Title: Advisory Committee on Reactor Safeguards
 Plant License Renewal Subcommittee
 Prairie Island Nuclear Generating Station

Date: Tuesday, July 7, 2009

The purpose of this meeting is to review the application for the Prairie Island Plant License Renewal, the Draft Safety Evaluation Report, and associated documents. We will hear presentations from the representatives of the Office of Nuclear Reactor Regulation and the applicant, Northern States Power, a Minnesota corporation.

Containment Vessel

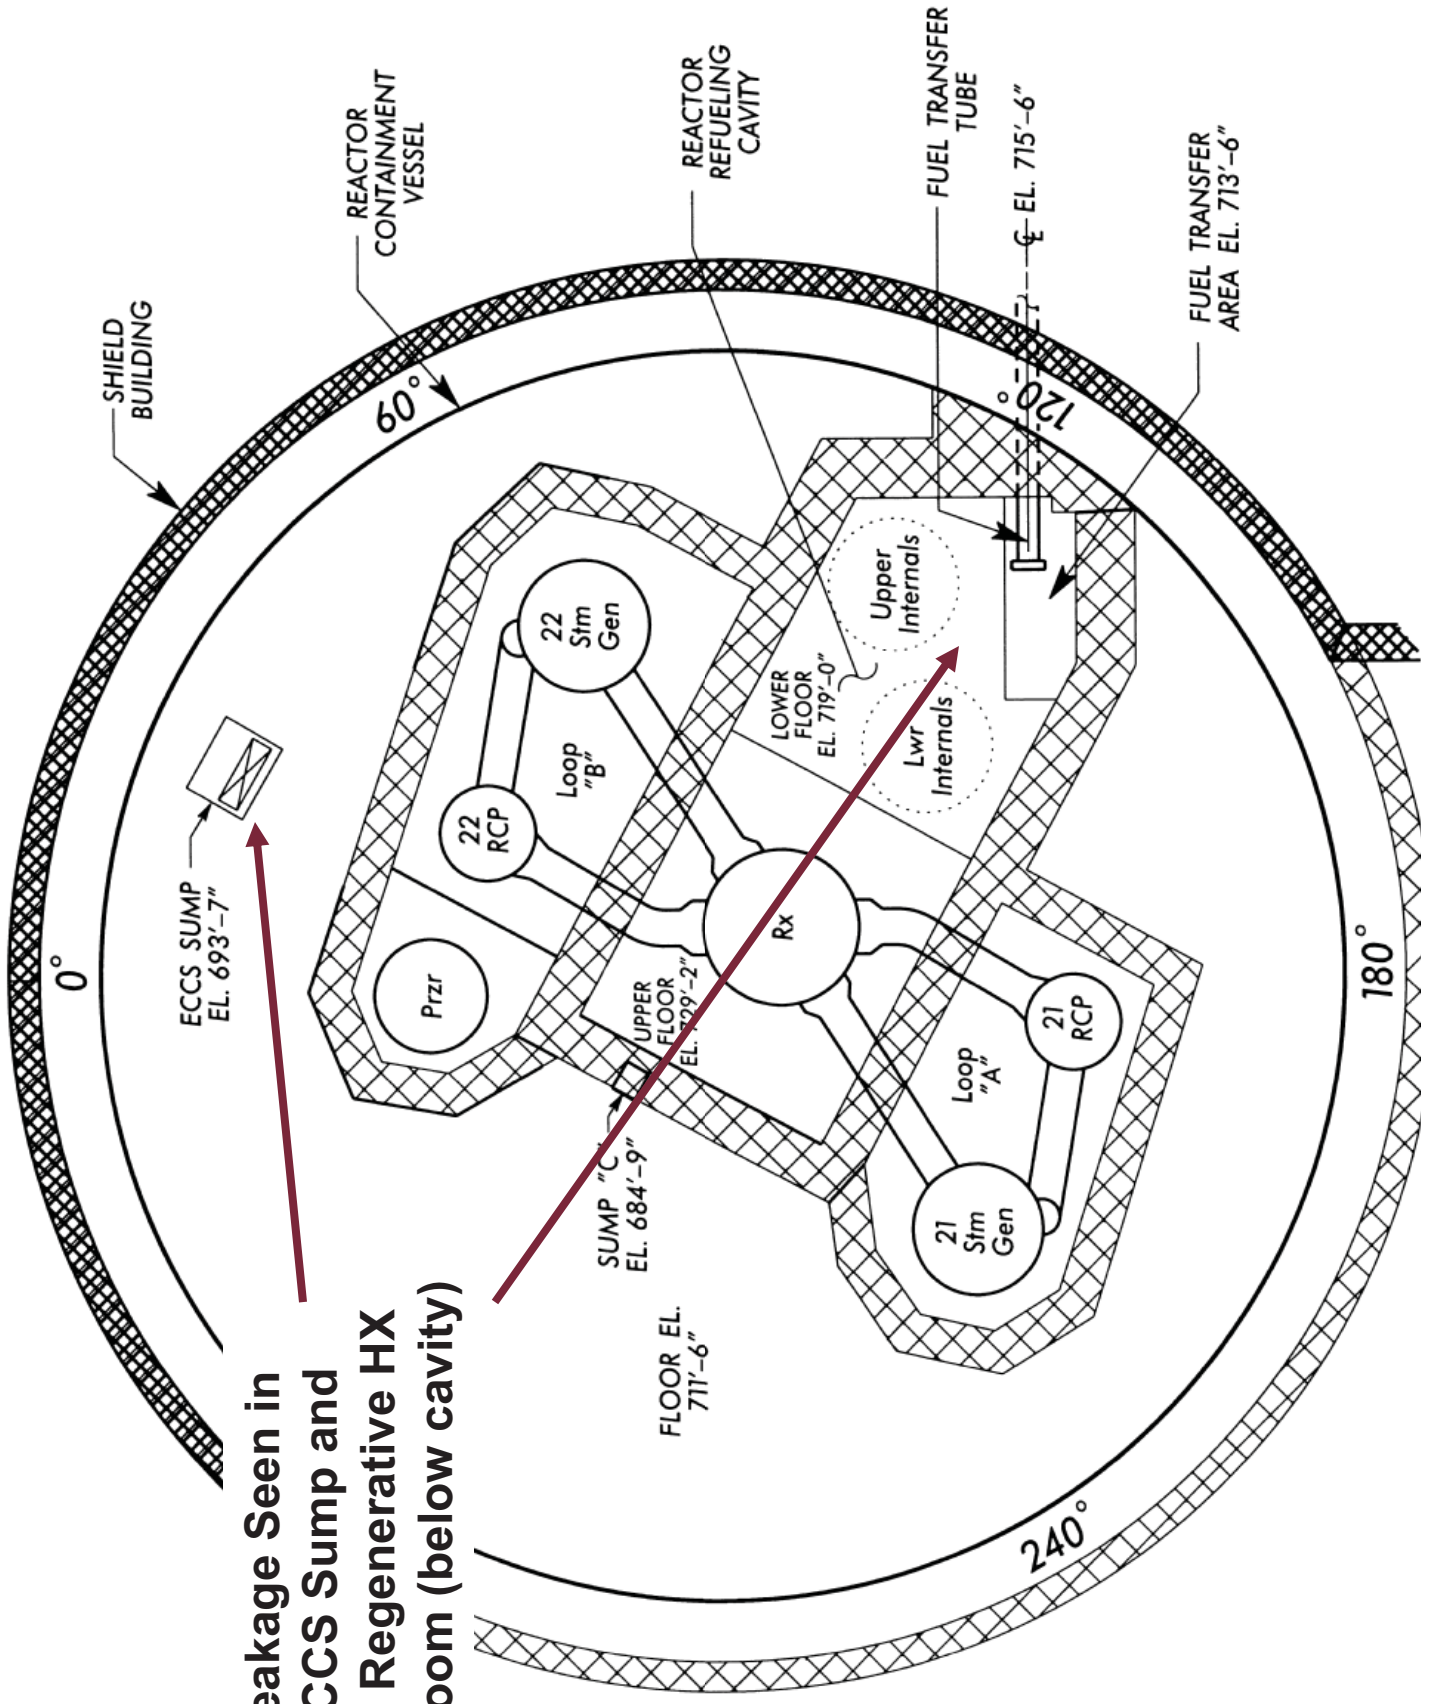
19 Actually, if you turn to the last slide
20 in your presentation -- we did include a figure so we
21 can look at that. The containment pressure vessel
22 itself has an inch and a half thick bottom head, an
23 inch and a half thick shell, and the top head is 3/4
24 of an inch thick.

5 The lower head, as you can see in the
6 drawing, is fully encased in concrete on both sides.
7 The remainder of the containment pressure vessel --
8 and there's a five foot annular gap between the
9 containment vessel itself and the one in the leakage
10 -- reinforce the concrete shield building. That
11 allows us access to the vast majority of the
12 containment pressure vessel itself.

Refueling Cavity Leakage Leak Locations

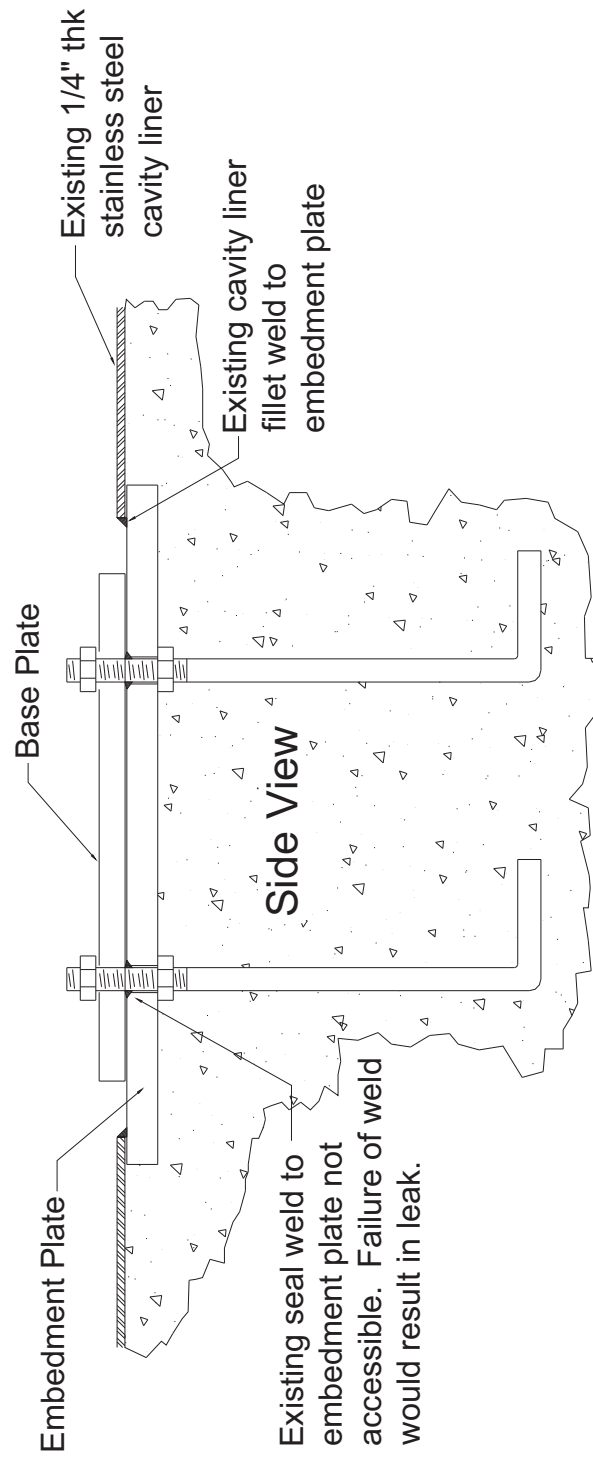
7 MR. SKOYEN: Okay, the top view, you'll
8 notice our ECCS sump -- that's at an elevation of
9 693.7. 693 and 7 inches. We didn't see that in the
10 prior view because it was in a different plane.
11 That's typically where the leakage would show up, in
12 that particular location.

8 MR. SKOYEN: That's correct. That's the
9 location that we're referring to on this particular
10 slide, in the center -- the cut-away drawing in that
11 particular location.

Refueling Cavity Leakage Leak Locations

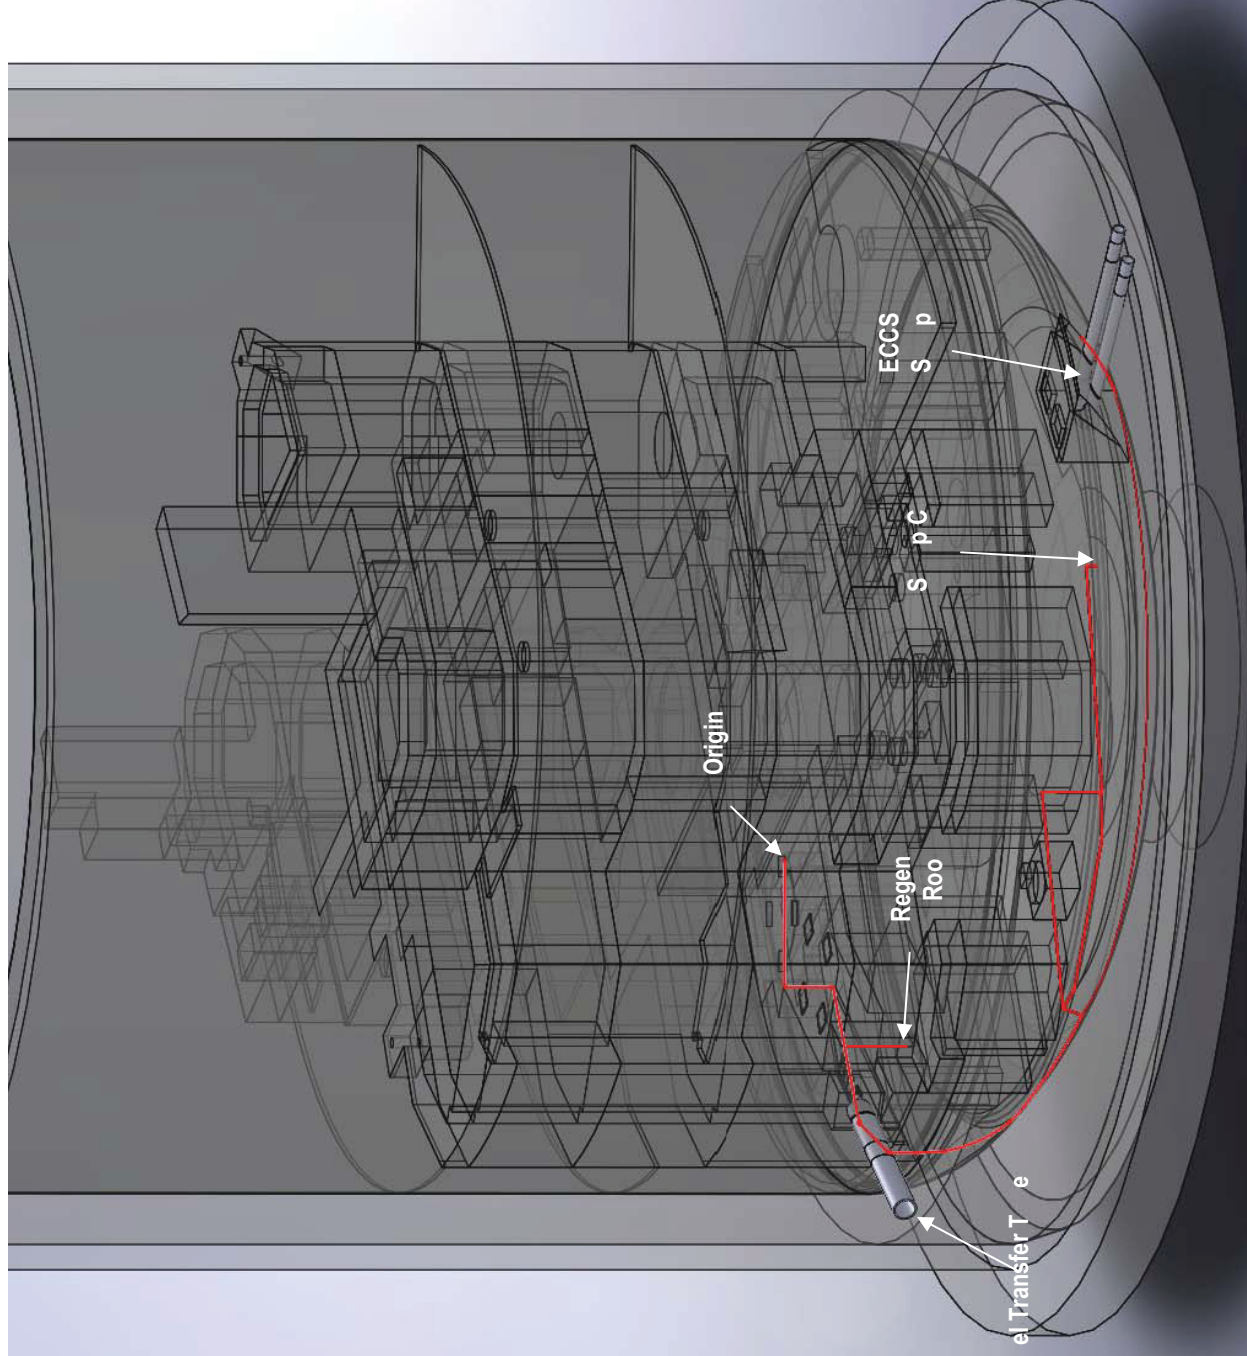
21 The actual leak locations themselves, the
22 typical reactor vessel internals support stand is in
23 the left and the typical RCC change fixture support
24 stand is on the right. There are eight internal
25 support stands and we have three NRCC change fixture

2 The leakage, we believe to be flowing the
3 threads down past the nut. Once past the nut, there's
4 a seal weld -- this is the RCC change fixture -- seal
5 weld that was installed when this was originally put
6 in.

17 MR. SKOYEN: Yes. Past actions that we've
18 taken, most recently was caulking and we would remove
19 the nuts from the top of the base plate, underneath
20 those nuts to prevent the leakage from going past the
21 threads. Then between the base plate and the
22 embedment plate, we would try to caulk there.

3 MR. SKOYEN: All right. We plan to prepare
4 to permanently eliminate the leakage during our next
5 refueling outage on each unit.

1 permanently eliminate the leakage that occurs from
2 both the internal stands and the RCC change fixture
3 support stands.
